NSW GOVERNMENT
Planning
Issued under the Environmental Planning and Assessment Act 1979
Approved Section 75W Modification Application
No. 2 granted on the 18 April 2017
in respect to MP 10-0016
Signed [Signature]
Sheet No. 1 of 20

PROJECT:
The Terraces
Seniors Living and Residential Aged Care Facility
74 Brown Street Paddington NSW 2021

DRAWING TITLE:
LEVEL 01 PLAN - BROWN STREET BUILDING

S75 W APPLICATION

DRAWING TITLE:
LEVEL 09 - ROOF PLAN - BROWN STREET BUILDING

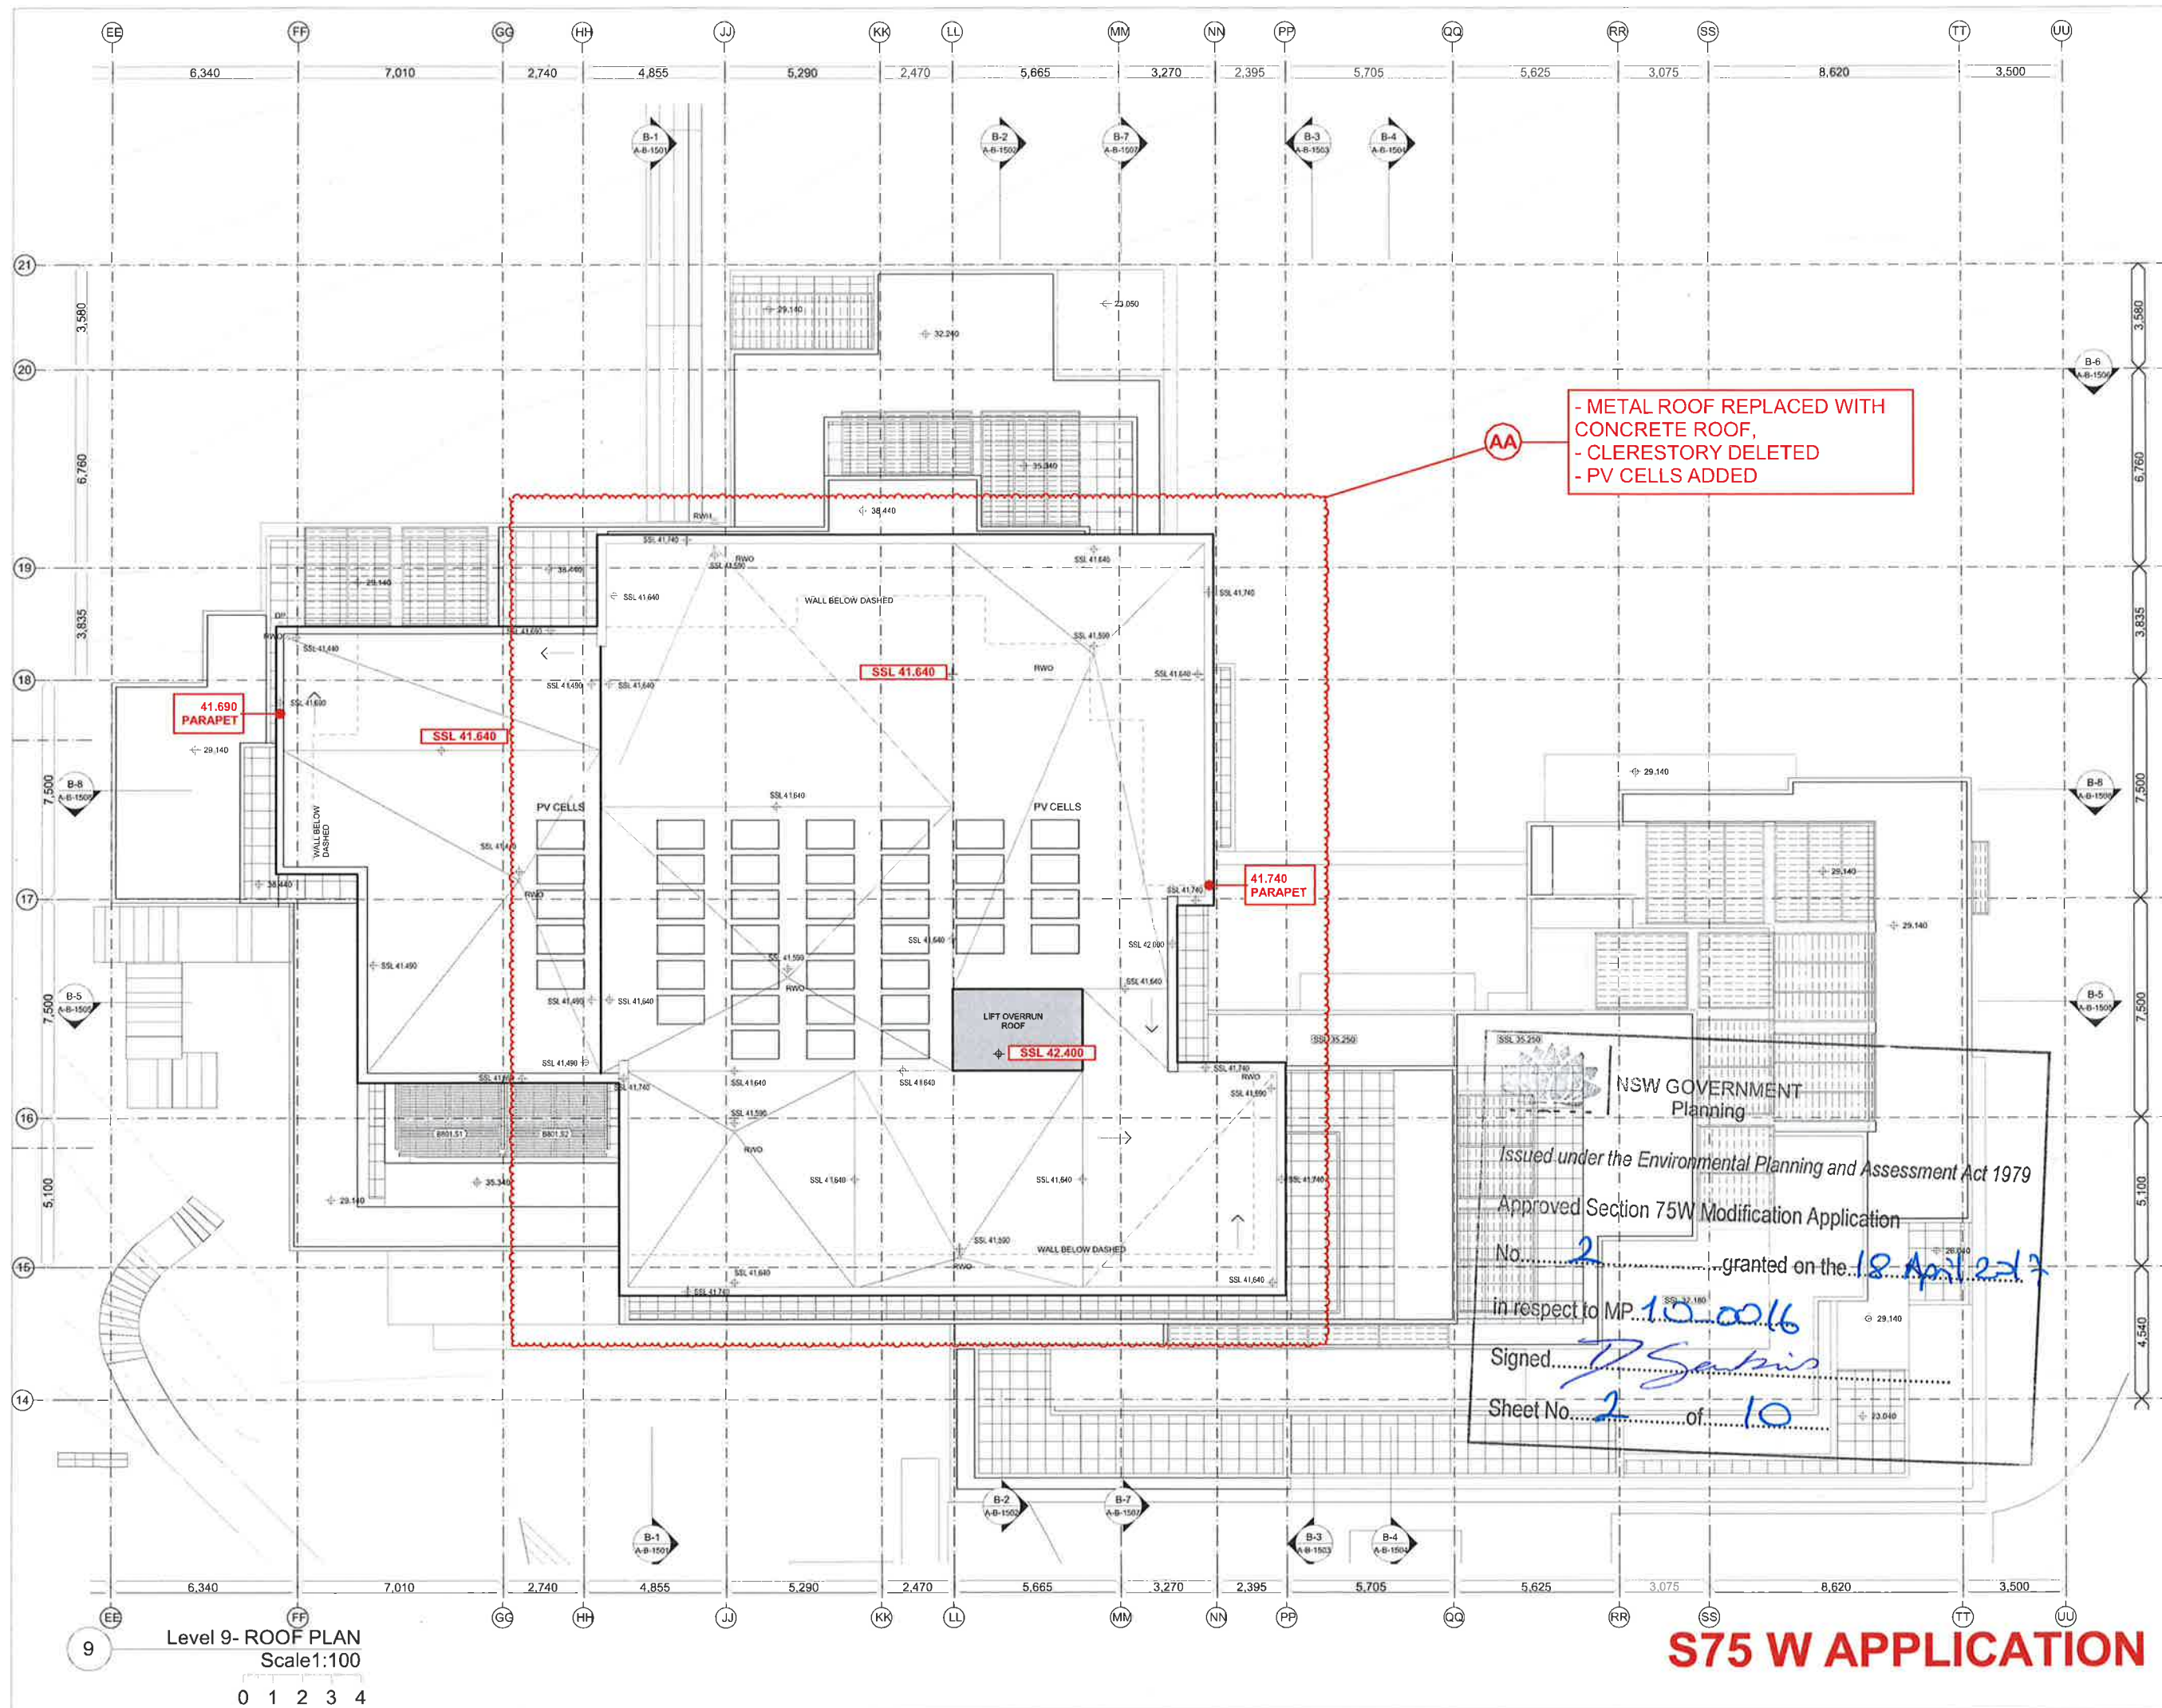
AA	10/06/16	S75 APPLICATION
		BROWN ST - METAL ROOF REPLACED
		BROWN ST - CLERESTORY DELETED
		BROWN ST - PV CELLS ADDED

2 East to West Sec 01- Brown Street
Scale 1:250

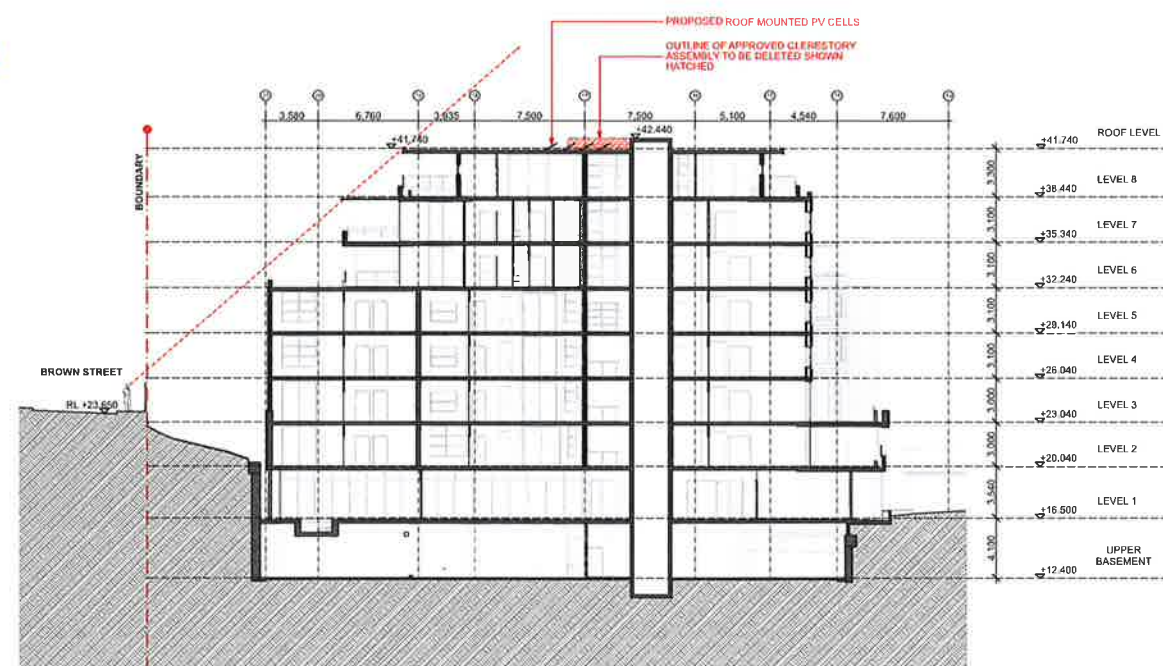
REVISIONS	DATE	DESCRIPTION
1	16/06/16	75W APPLICATION EAST TO WEST SECTION ACROSS BROWN STREET ADDED

1
Level 6
Scale 1:250
0 10

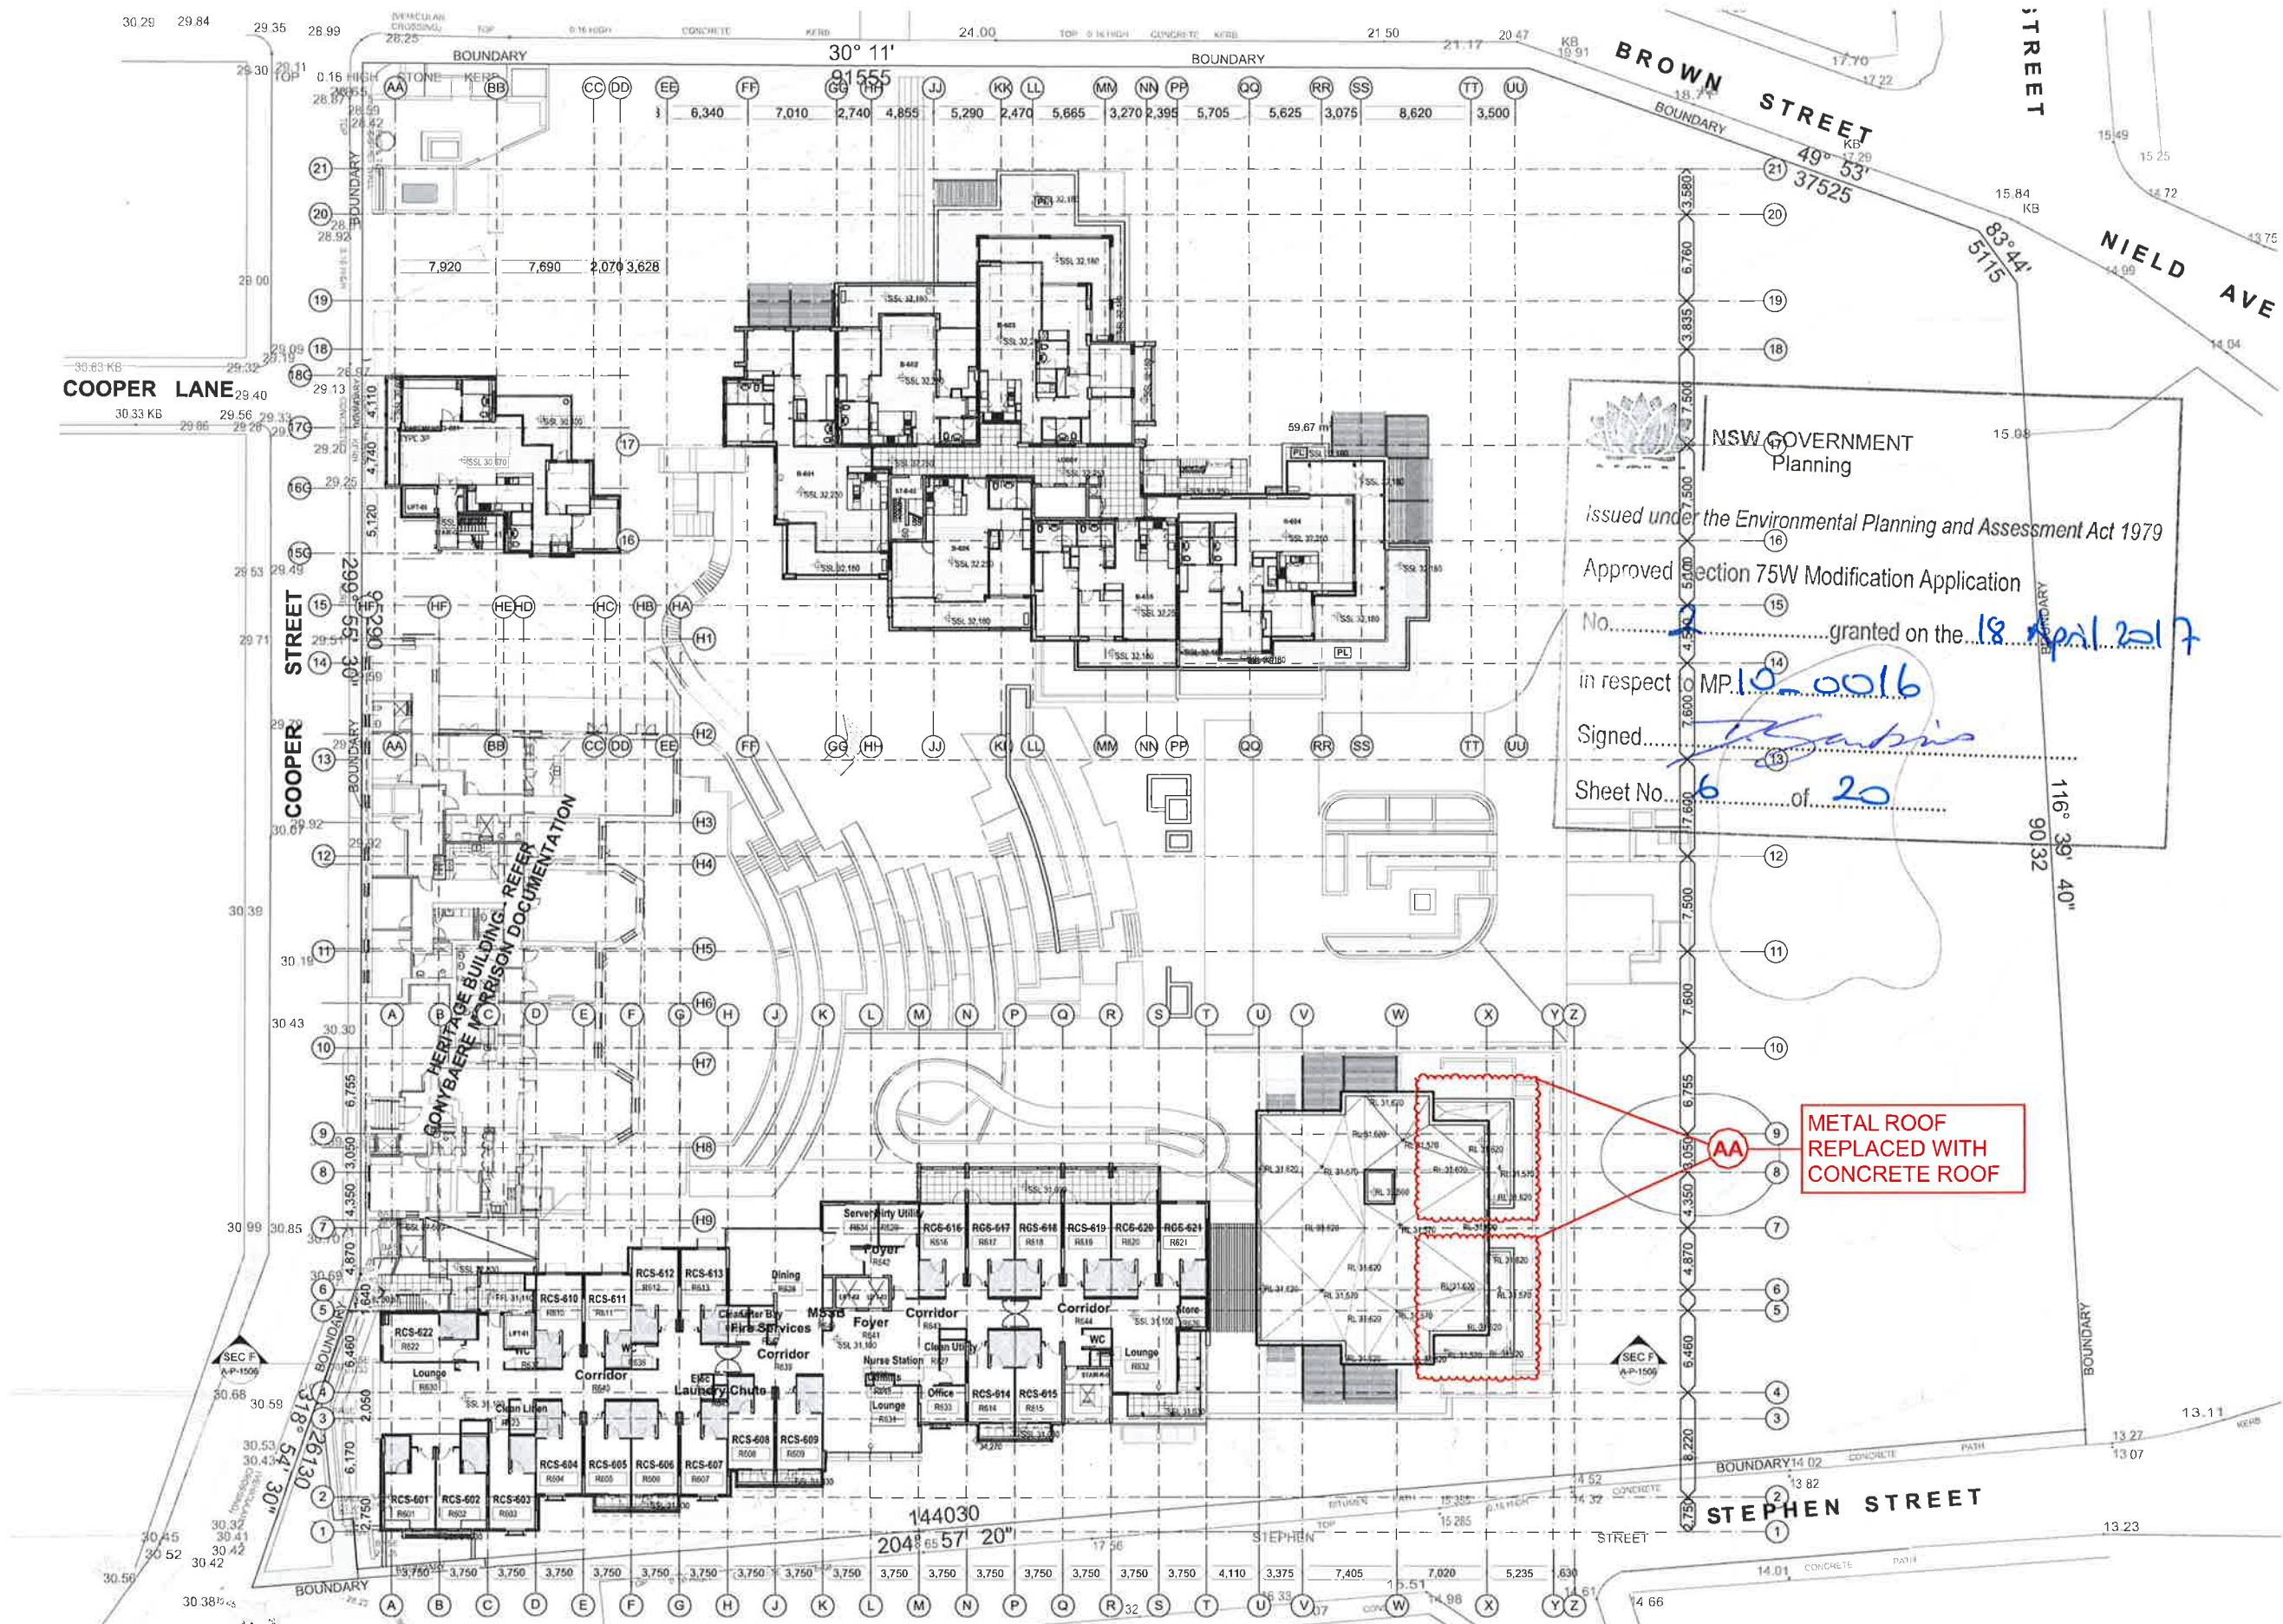
NO.	DATE	DESCRIPTION
AA	16/06/16	S75 W APPLICATION
		STEPHEN ST - METAL ROOF REPLACED
